Road Safety Audit
Stage 1
For
WESTGATE VISION AREA
PUBLIC REALM/URBAN REGENERATION SCHEME
WESTGATE, DROGHEDA, CO LOUTH

Reference: RSM/MOB/081222/WESTGATE RSA1

Client	Louth County Council
Project Title	Westgate Vision Area Regeneration Scheme, Drogheda, Co Louth
Document Title	Stage 1 Road Safety Audit
Document Ref.	RSM/MOB/081222/WESTGATE RSA1
Status	FINAL

Figure 73: Crossing configured as signalised raised crossing

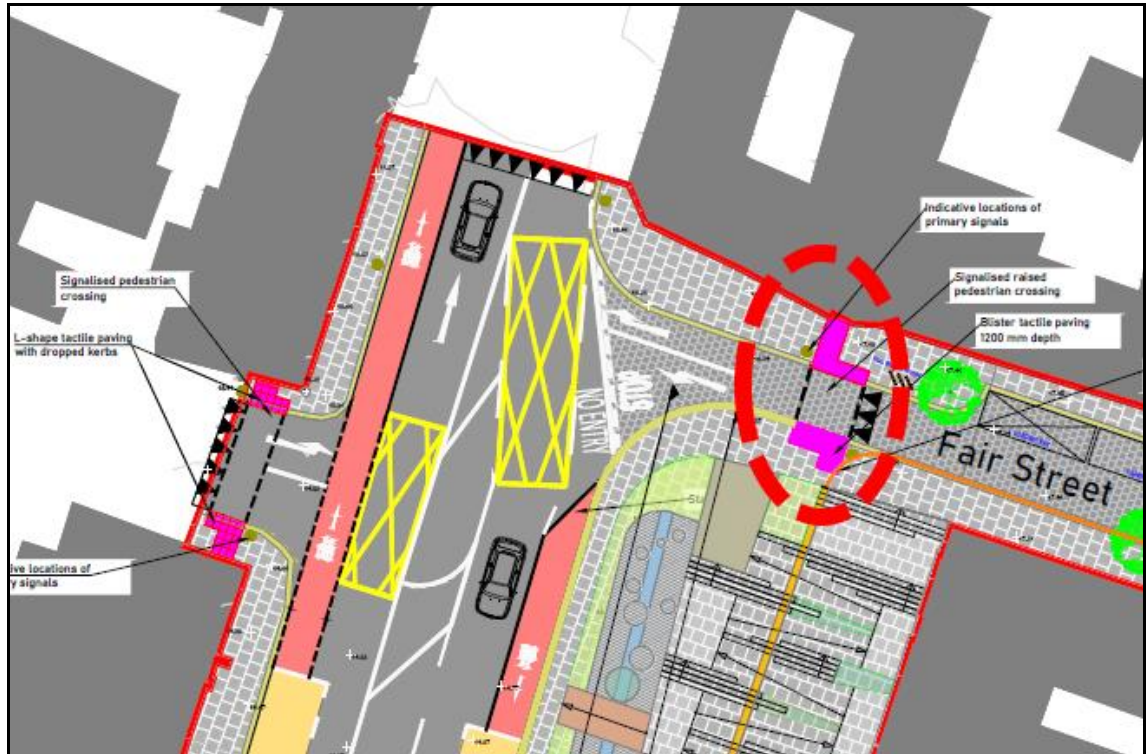
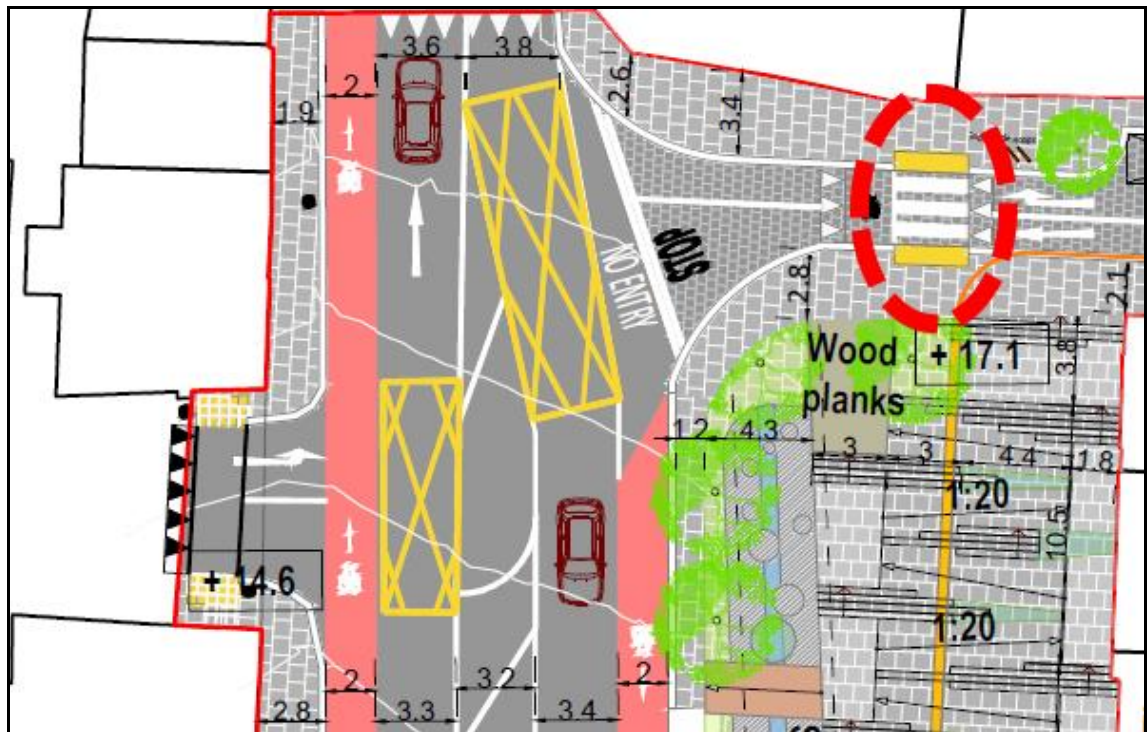
A standalone signalised pedestrian crossing is proposed on Fair Street in close proximity to the intersection with Georges Street, however the layout of the crossing is ambiguous, with zebra markings shown on one plan and a signal controlled crossing shown on another, as shown in figures 73 and 74. Ambiguous layouts, which do not conform to standard layouts can increase the risk of misinterpretation regarding rights of way and priority, leading to an increased risk of pedestrian/vehicular conflict. It is unclear if this crossing point is to be integrated into the

signalised operation of this junction, as the three other arms on the junction will operate with signal control.

**Figure 77: Proposed Steps to south of Fair Street
Note: trip hazards arising where dropped kerbs are provided at raised crossing points**

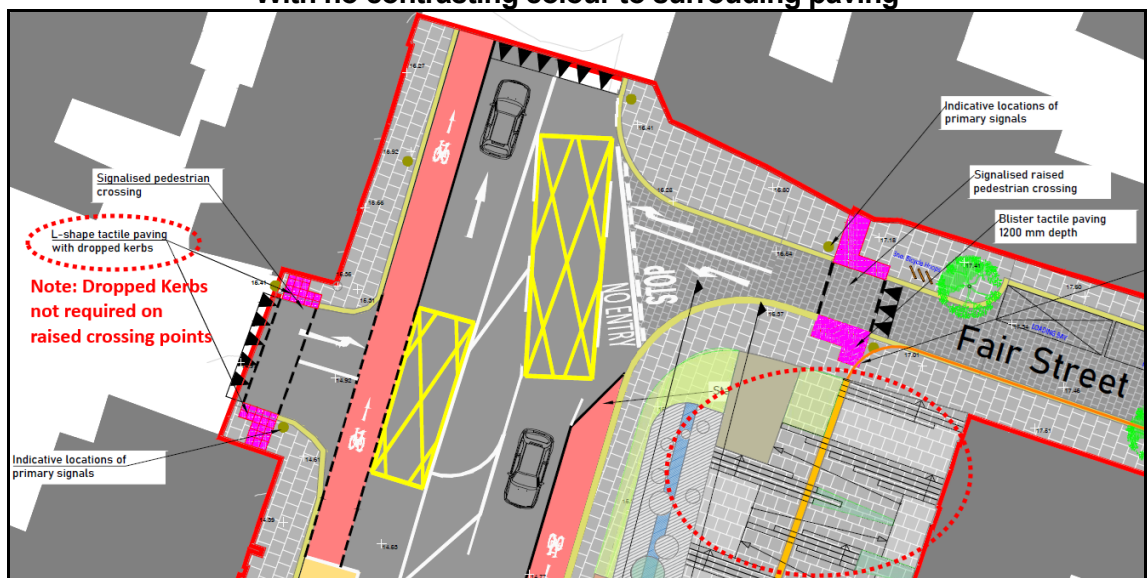
Provision has been made for visually and mobility impaired pedestrians through proposals for blister tactile paving at a number of formal and informal crossing points throughout the scheme to alert visually impaired pedestrians to the presence of the crossings and the potential for conflict with traffic, however provision is inconsistent in respect of colours and configuration, and the width of a number of the crossings and associated dropped kerbs is narrow, and may not safely

Figure 83: Intervisibility compromised by parking bays, landscaping and building lines

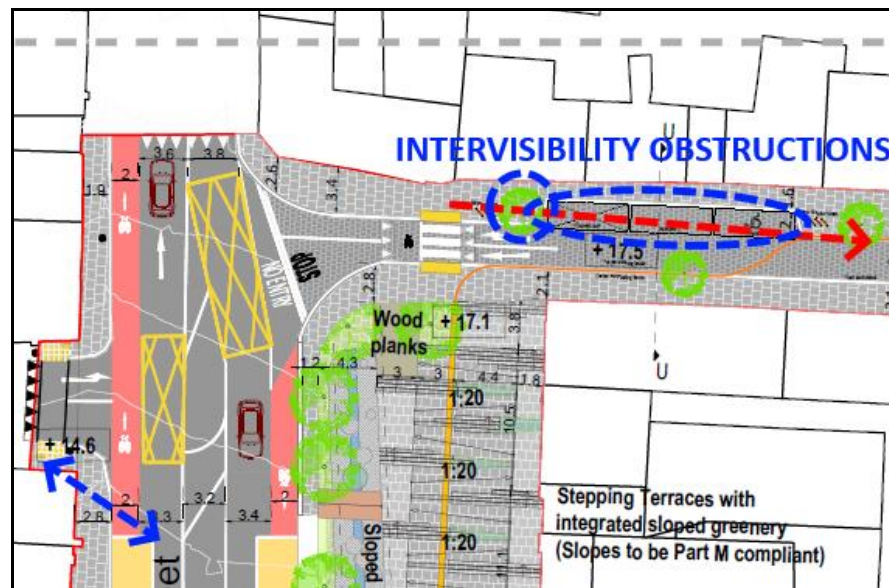
- The provision for continuity of a number of pedestrian routes is not clear at some locations, particularly at tie-ins, and pedestrians may inadvertently walk out into the path of vehicles on desire lines where the layout and priority are ambiguous, and intervisibility may be restricted by building lines and other street furniture, landscaping and parking.
- Intervisibility at a number of pedestrian crossing locations will be compromised by the location of landscaping and parking bays adjacent, with an example of where this occurs shown in figure 83.

Figure 88: Reduced intervisibility to/from left at crossing

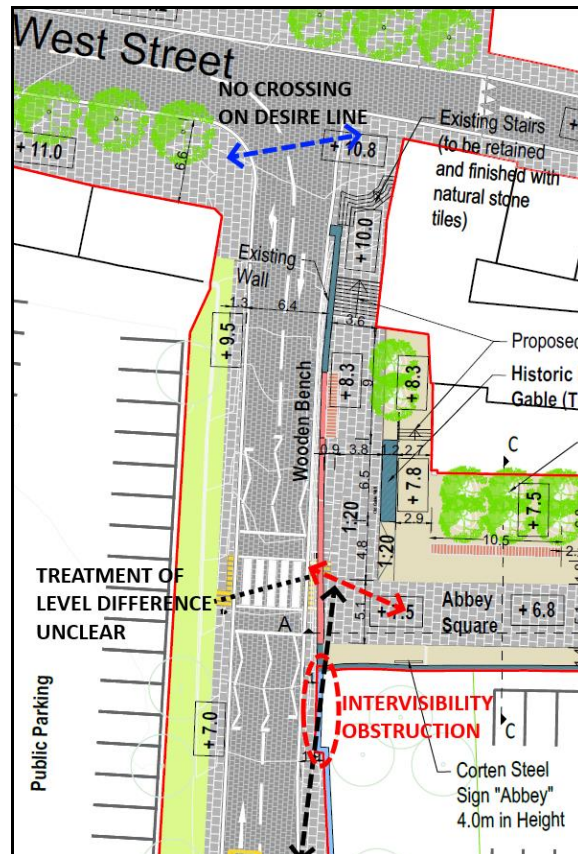
- Intervisibility to/from the south from the eastern side of the crossing is also likely to be obstructed by current boundary treatment/wall to the south, as highlighted in figure 88.

5. The treatment of the level differences between Father Connolly Way and Abbey Square should be clarified, with suitable gradients (maximum 5%) to be provided on the desire line between the crossing and the Old Abbey, and with no sudden change in gradients at the tie in on Abbey Lane to the north. New crossings should not be provided on roads with gradients exceeding 5%.

Figure 92: Narrow proposed footway on Riverside

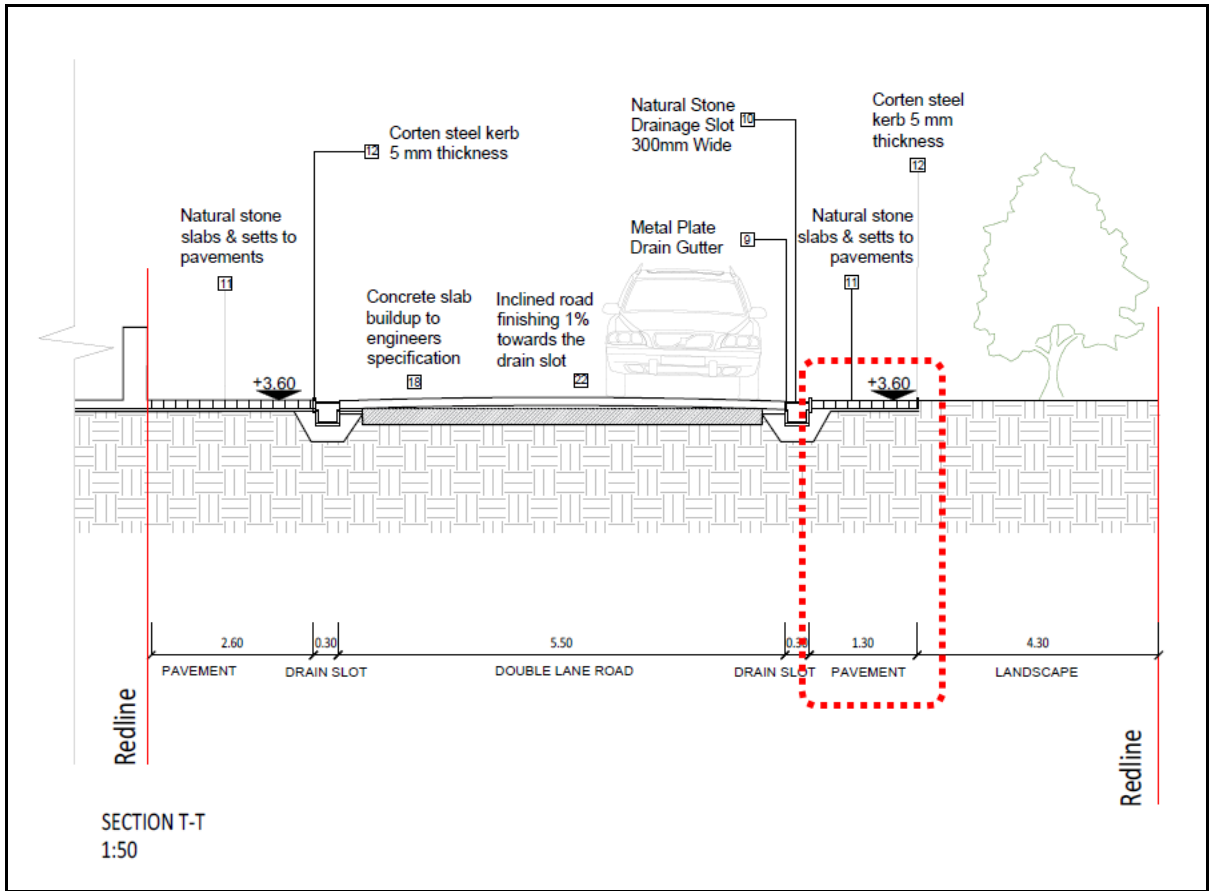
Footways are narrow with substandard widths at a number of locations throughout the site, and there is insufficient space for disabled or mobility impaired road users to pass safely at some locations throughout the site due to the location of street furniture, which may force pedestrians out into the path of oncoming vehicles. Narrow footways and VRU routes are contrary to the aspirations of DMURS which advocates the reallocation of space on the cross section for the benefit of VRUs. Mobility and visually impaired pedestrians in particular may be more vulnerable on narrower footways with potential obstructions from street furniture and where no separation distance has been provided, and where there is no longitudinal tactile guidance.

5. An absolute minimum footway width of 1.2m is acceptable at isolated locations only, however sufficiently greater width should be provided wherever possible to provide a greater degree of protection to pedestrians within the urban zone, and to facilitate accessibility for the mobility impaired.

Figure 111: Cross Section showing no crossfall, clearance to hazards or linear tactile delineation

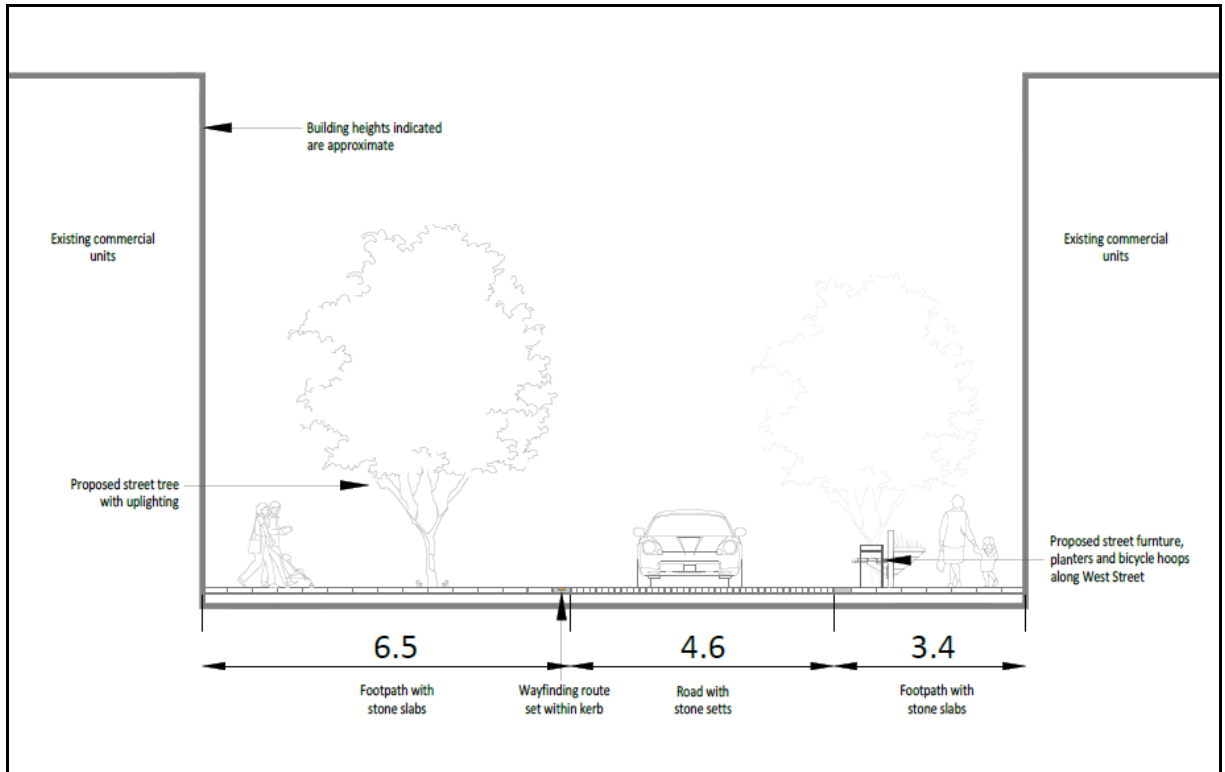
There is no provision for pedestrian accessibility on all desire lines throughout the site, with an example shown in figure 112. Pedestrians wishing to travel to and from Old Abbey Lane or West Street and the Dominic Street Car Park will need to travel on a longer distance in conflict with vehicles turning to and from the relocated car park entrance, where there is no provision for segregated access for VRUs, particularly those who are mobility impaired.

Figure 116: New Lane arrow markings at signalised crossroads

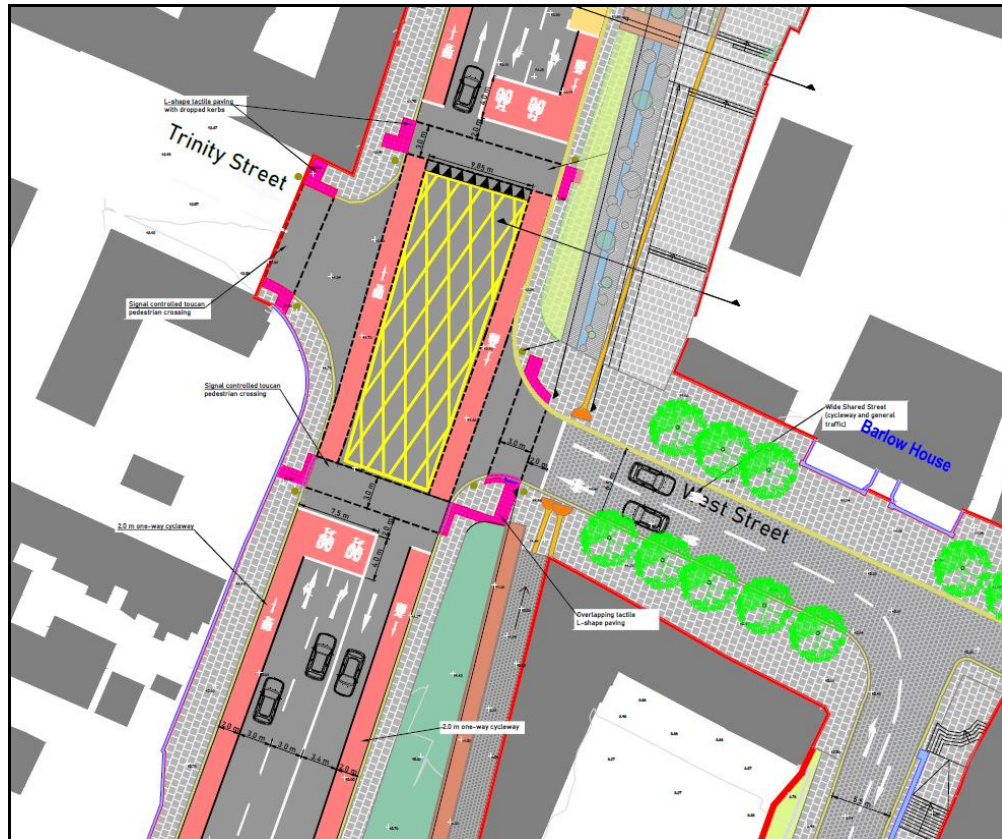
- There is no provision for removal and replacement of existing road markings (left turn only in Lane 1 and straight ahead in lane 2) for road users travelling northbound on George's St (R132) across the Bridge of Peace over the River Boyne, where the new layout will require reconfiguration of edge of lane delineation, arrow markings, and destination markings further upstream, as well as suitable tie ins to the central reservation which is to be removed within the scheme extents.

10. Redundant road markings and signs should be removed where necessary to prevent driver confusion and misinterpretation of the new layout.
11. Provision should also be made for turning circles and safe unobstructed emergency vehicle access where necessary within the adjacent sites where previous through routes were possible and are now terminated (e.g. to/from Courthouse from St Patrickswell Lane, which will be pedestrianised with no apparent provision for vehicular access on the preliminary design plans.

Figures 136 & 137: Zebra markings shown with inconsistent layouts for crossings in close proximity

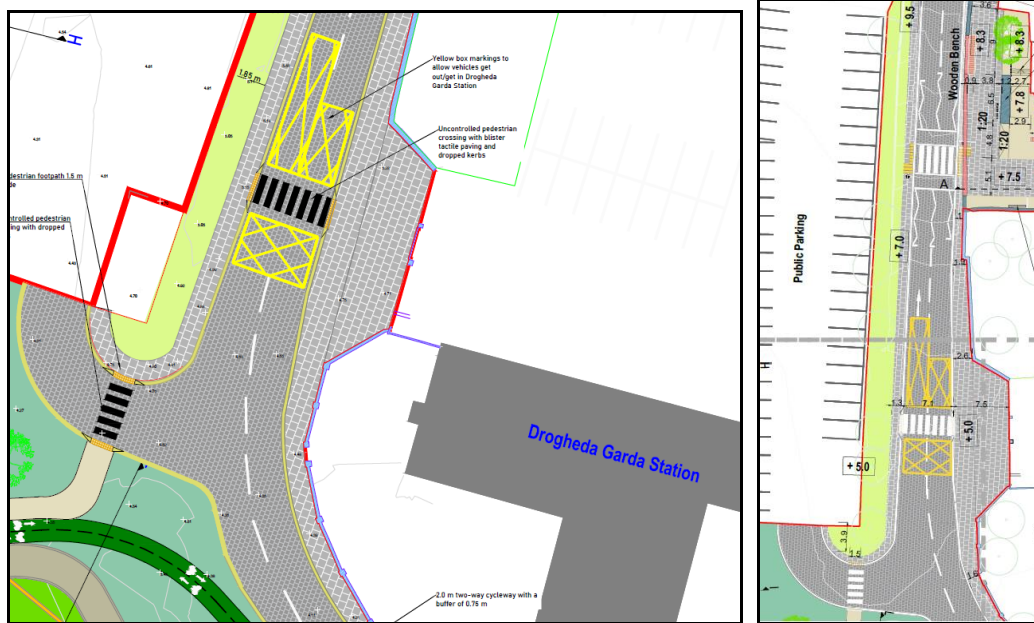
- Zebra road markings have been provided at a number of the informal uncontrolled pedestrian crossing points, however there is no provision for standard road markings, Belisha Beacons or L shaped red tactile paving. Zebra road markings are typically only used at controlled pedestrian crossing points and accompanied by these standard design measures. An ambiguous layout which does not conform to standard layout may result in misinterpretation

and ambiguity regarding rights of way, leading to an increased risk of vehicular/pedestrian conflict.
